ADDENDUM NO. 01

Project Name: TFSD 2023 Capital Improvements
Address: Twin Falls, Idaho

Date Issued: March 18, 2024

Addendum No. 01

C4 LEVEL 01 - DEMO CEILING PLAN
A2.01 1/8" = 1'-0"

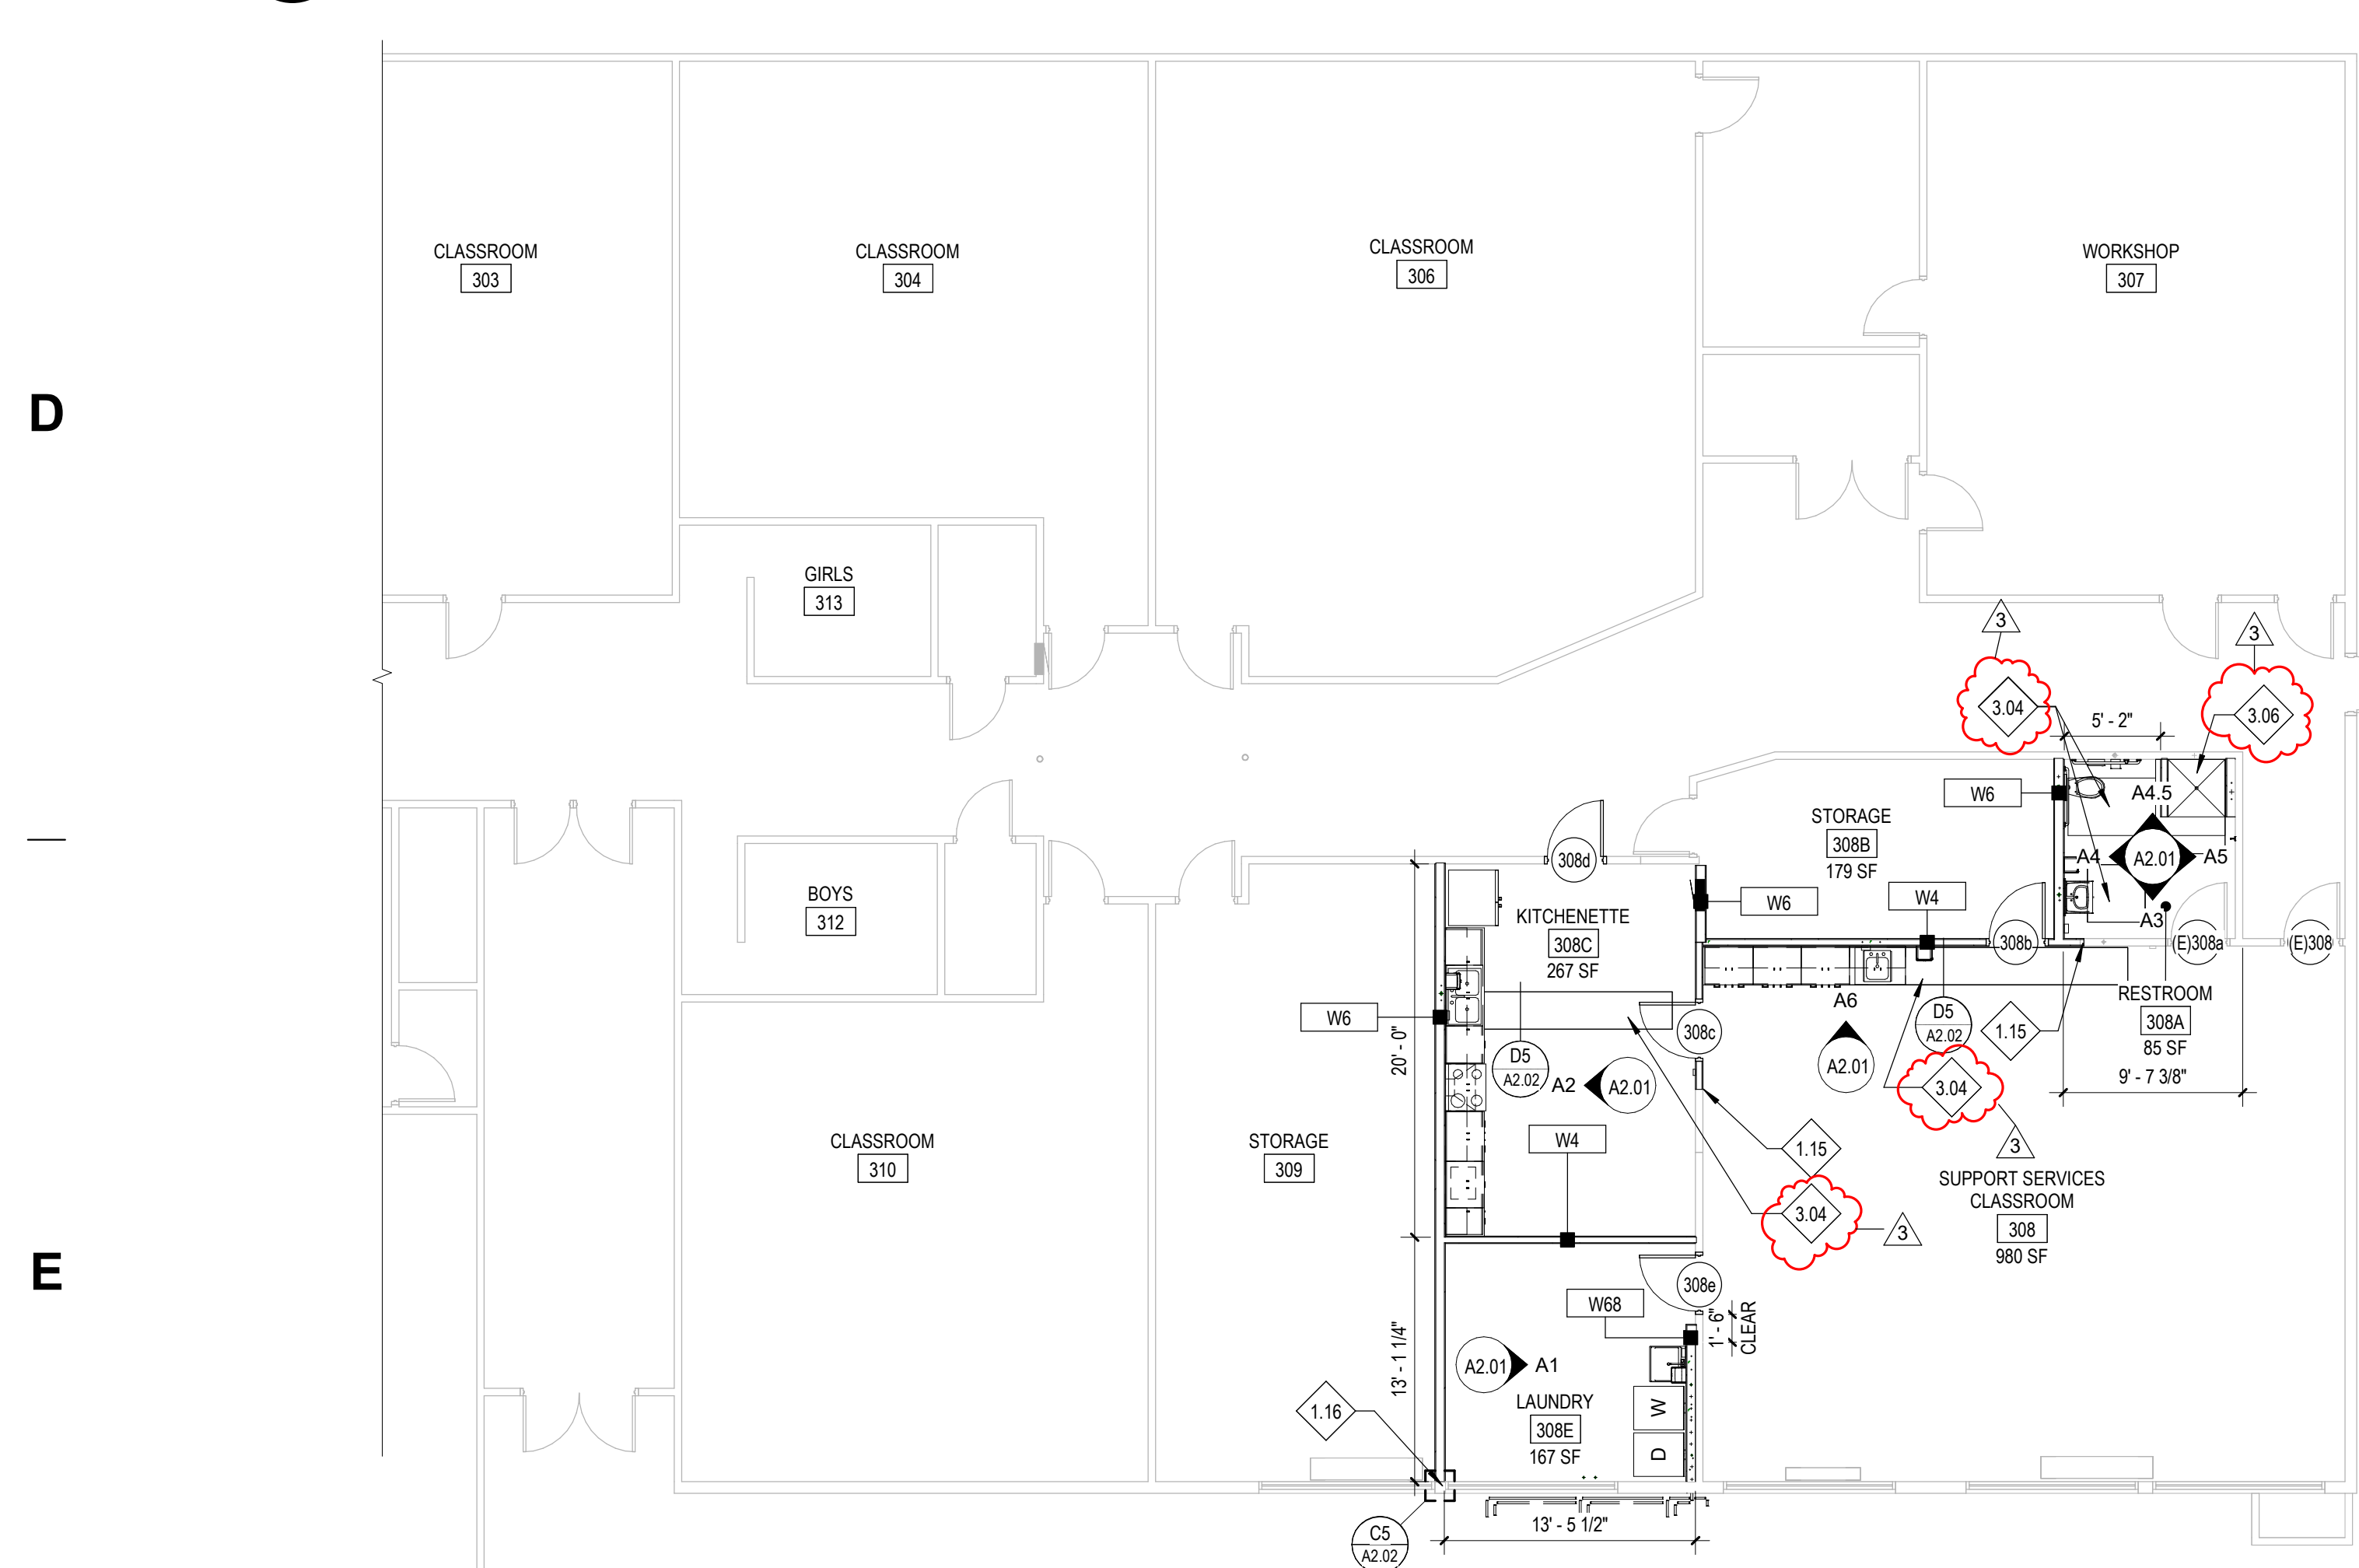
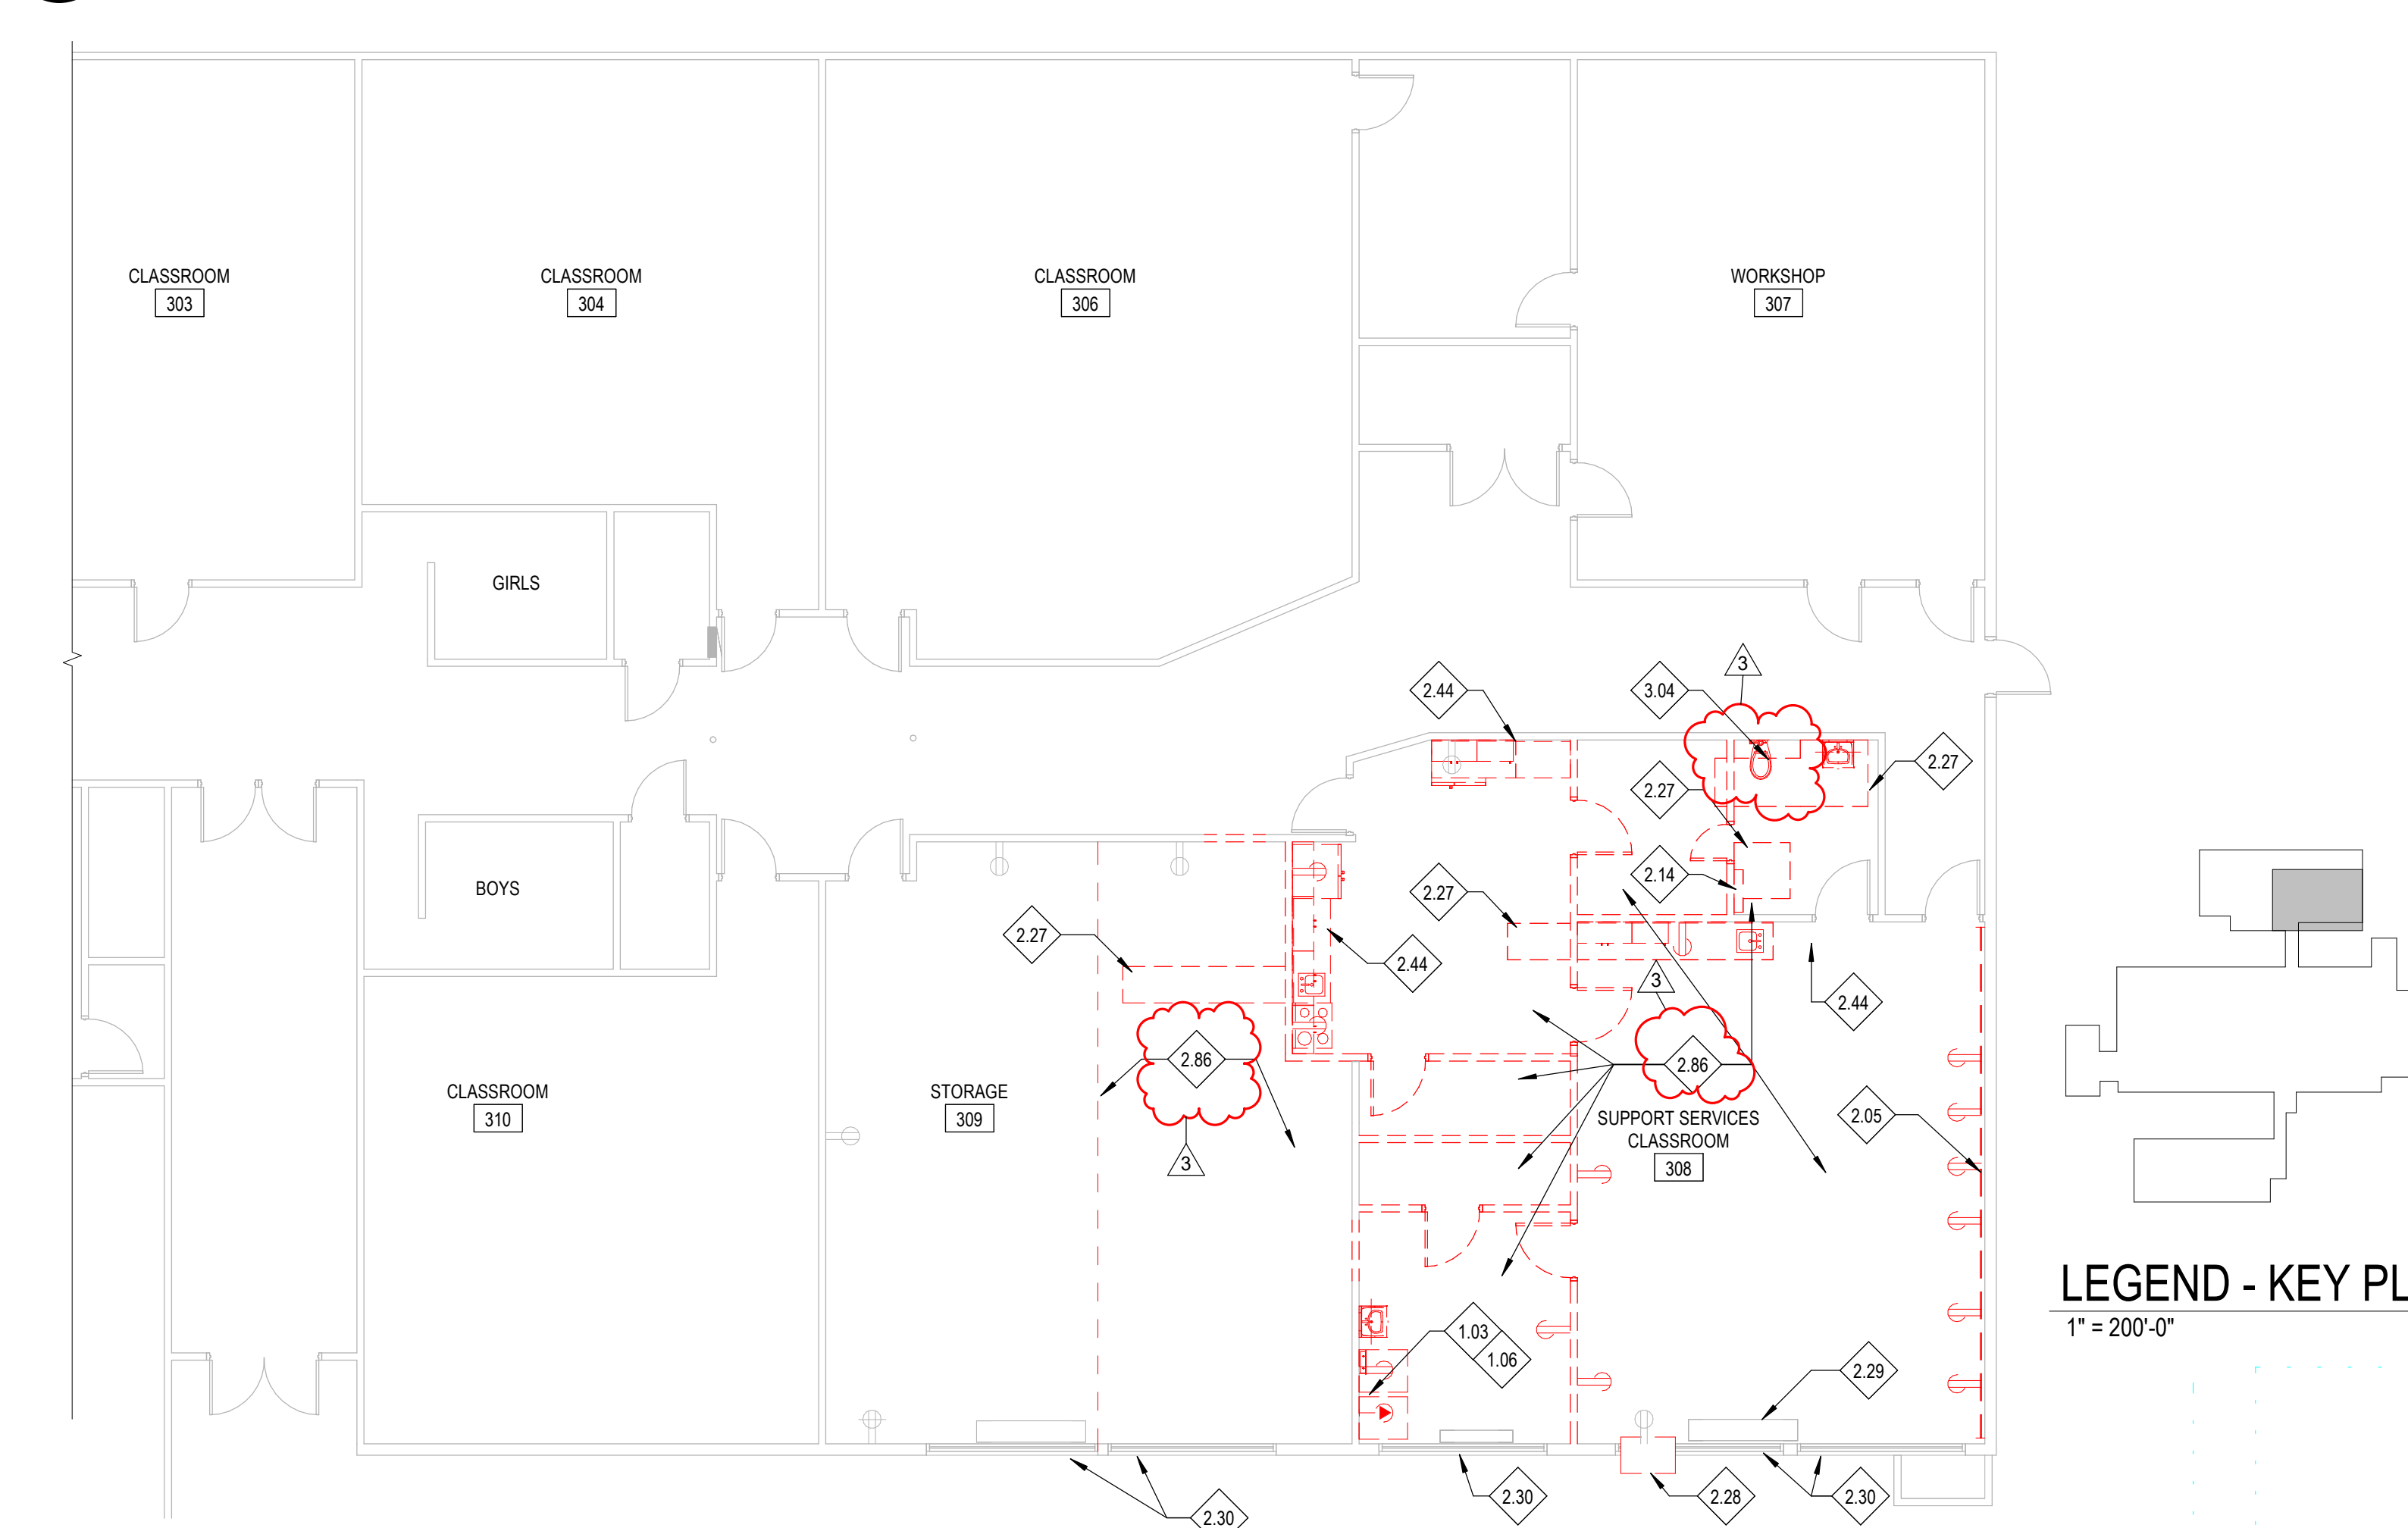
Question: O'Leary and Robert Stuart plan sheets A2.01 & A2.02 does not have a call out for the floor existing floor finishes. We would assume under all new flooring old tile or carpet to be removed? Also, is there a asbestos survey for the O'Leary, Robert Stuart, Morningside & Harrison, that we could obtain.

Revise extent of demo on existing slab to include floor at new shower within Restroom 308A and provide new concrete slab patch with slope to drain at the shower. See revised Plumbing for connection to floor drain at shower.

Response: See attached revised sheets for demo of existing floor finishes at Robert Stuart and O'Leary Middle Schools. See response from Construction Manager for materials testing report.

3.04	CONTRACTOR TO PATCH CONCRETE FLOOR FLUSH TO ADJACENT EXISTING SLAB INCLUDING SUBGRADE PREP. SEE DETAIL DS/A2.02.
3.06	CONTRACTOR TO PATCH CONCRETE FLOOR INCLUDING SUBGRADE PREP AT SHOWER SLOPED TO DRAIN WITH A FLUSH TRANSITION TO ADJACENT SLAB. SEE DETAIL DS/A2.02.03, FLOOR FINISH PLAN AND PLUMBING PLANS.

Sheet P0.01 - PLUMBING LEGENDS, NOTES & SCHEDULES

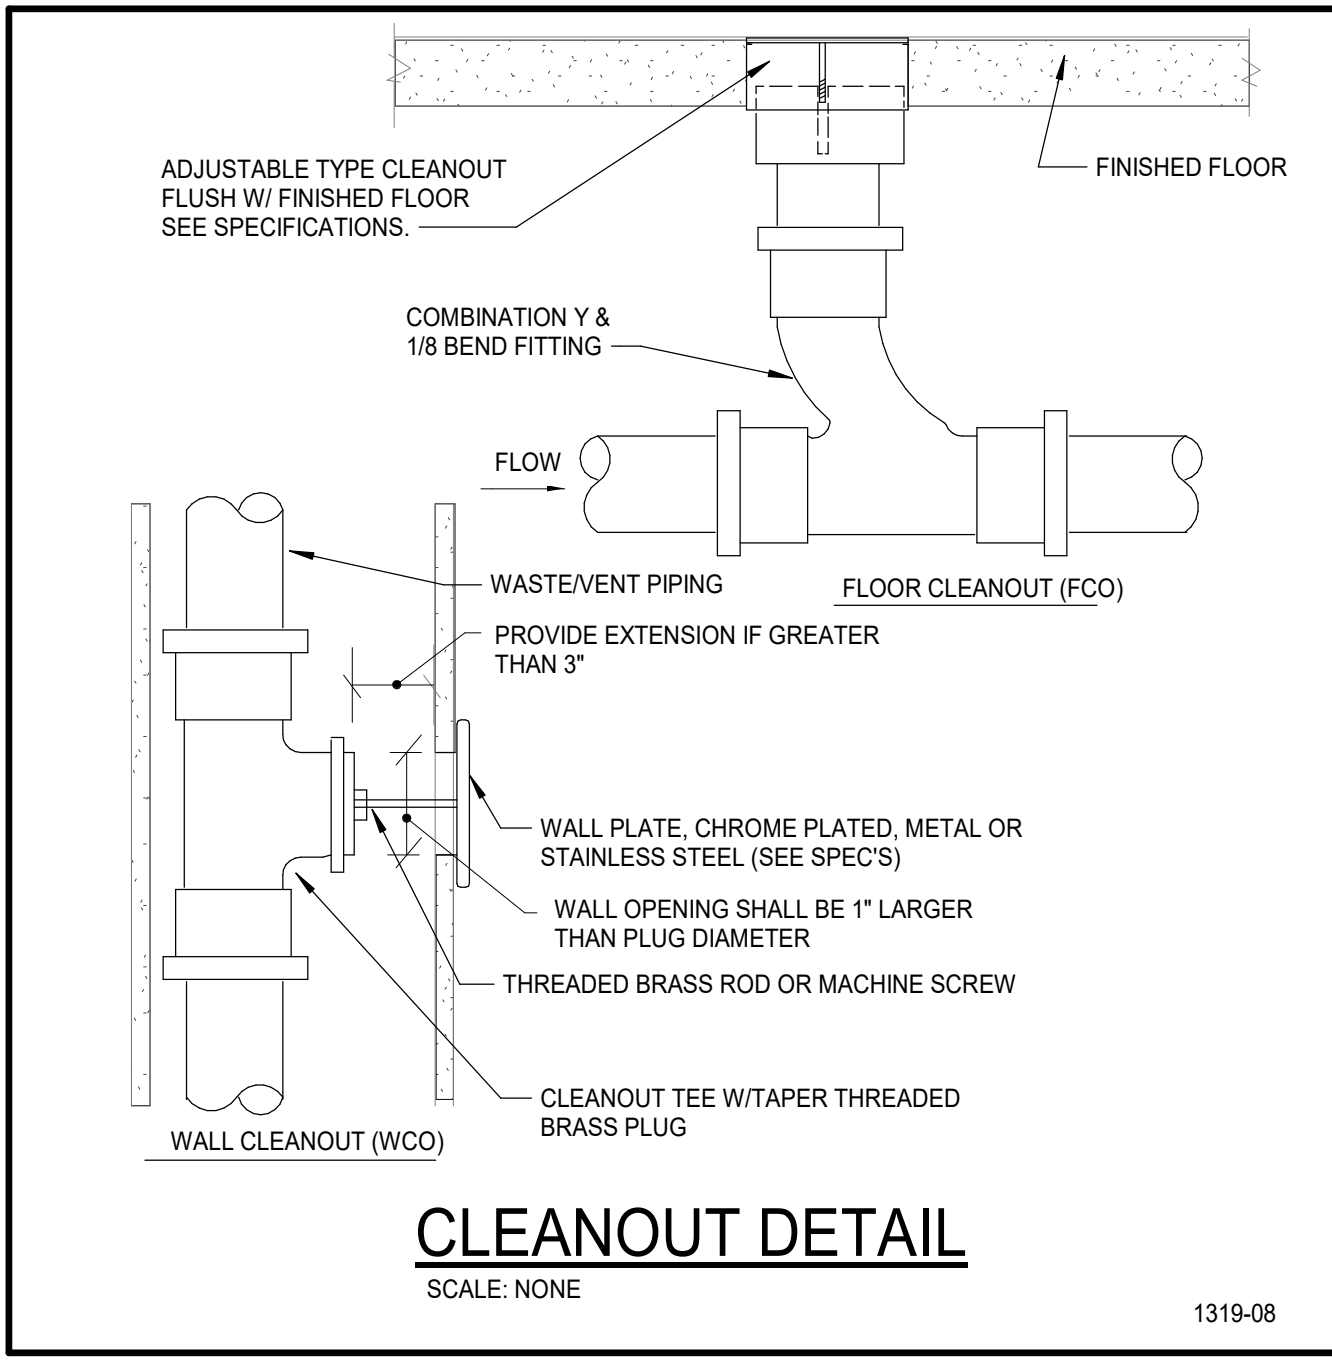
- **Response to RFI Question 3: Shower P0.01**
Question: Verify that per the specifications the shower in Robert Stuart will be a fiber glass per spec section 224000-6 I- Pre-Fab Shower is correct. Also is there suppose to be a drain under this shower, nothing really shown per P2.01?

Response: See attached revised Plumbing drawings indicating tiled shower with trim and drain provided in updated plumbing fixture schedule. Pre-fab shower insert is not included in this scope of work.
